HAVANT BOROUGH COUNCIL
DEVELOPMENT MANAGEMENT COMMITTEE
18 August 2016

8(1) APP/16/00707 - War Memorial, St Faiths Church, West Street, Havant, 1 - 12
PO9 1EH

Proposal: Variation of Condition 2 of Listed Building
Consent APP/15/011356 for the retention of font
type 'Copperplate Gothic Bold' in respect of
existing and future commemorations.

Application No: APP/16/00707 Expiry Date: 02/09/2016
Applicant: Mrs D Pink
 Havant Borough Council

HAVANT WAR MEMORIAL
PLAQUE PROPOSAL

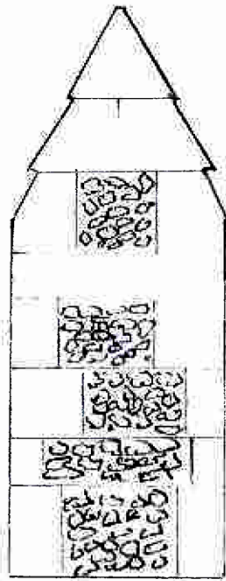
- The typeface is not the same
- The colour (patina) of the plaques is brown as opposed to black, although this may weather slightly over time
- The size of the lettering for the regiment and rank of each individual commemorated is not in the same proportion to the name as per the WWII plaques
- There are no commas after the names as per the WWI and WWII plaques

- The typeface is not the same
- The colour (patina) of the plaques is brown as opposed to black, although this may weather slightly over time
- The size of the lettering for the regiment and rank of each individual commemorated is not in the same proportion to the name as per the WWII plaques
- There are no commas after the names as per the WWI and WWII plaques

1. The font size to be used on the plaques shall match that used on other World War II commemorative plaques on the War Memorial; the font style shall be 'Copperplate Gothic Bold'.
